MEMORANDUM

REVIEW TYPE: **Major Amendment to Site Plan**
 CASE #: **82004022A (formerly 8-04022A)**
 PROJECT NAME: Greenway Village at Clarksburg—Phases 3, 4, 5

APPLYING FOR: Approval to: 1) add development standards for building heights and setbacks; 2) modify street designs to respond to Fire and Rescue Service requirements; 3) revise the design of Park 19 to reflect changes requested by M-NCPPC Parks staff; 4) revise street grades, intersection designs and street operations to reflect modifications requested by the Montgomery County Department of Public Works and Transportation; 5) revise the design of storm drains, stormwater management facilities and streets to reflect modifications requested by the Montgomery County Department of Permitting Services; and 6) modify the designation of bike paths for the purposes of the Site Plan Enforcement Agreement.

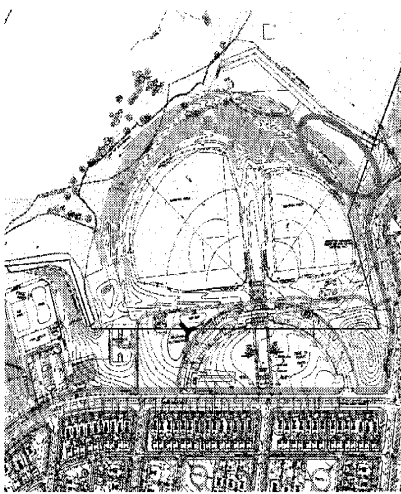
Montgomery County's Fire and Rescue Service has undertaken a review of subdivision and site plans in Clarksburg, in response to issues raised regarding access for emergency vehicles in the Clarksburg Town Center. The service has reviewed the site plans for Greenway Village and has mandated certain changes contained in a memorandum that will improve access for emergency vehicles. This memorandum recommends a condition of approval requiring the Certified Site Plans to

include all modifications required by the Fire and Rescue Service. The accompanying drawing offers an example of the required modifications. In it, grasscrete pavers have been added to the open space in front of two groups of attached houses so that emergency vehicles can have improved access. Where needed, lots will be modified to accommodate these proposals.

The development shall conform to changes mandated by the Montgomery County Fire and Rescue Service, in accordance with the memorandum dated December 30, 2005. (Appendix C)

Park 19

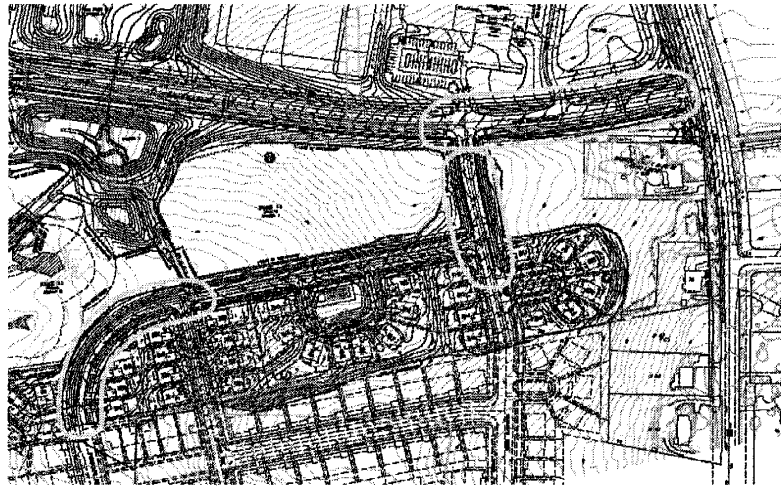
Greenway Village includes a local park that is located north of Skylark Road and west of Ridge Road, adjacent to Ovid Hazen Wells Recreational Park. As part of the overall project, the developer of Greenway Village will construct the park's facilities, which include baseball fields, basketball courts, picnic shelters and other play areas. This amendment revises the location of the baseball fields and revises the design of the semi-circular driveway that marks the entrance to the local park. These revisions, made at the request of Parks Department staff, will protect a forested stream valley buffer by limiting encroachment of the baseball fields. The Applicant must apply for and receive a construction permit from the Department of Parks prior to construction.
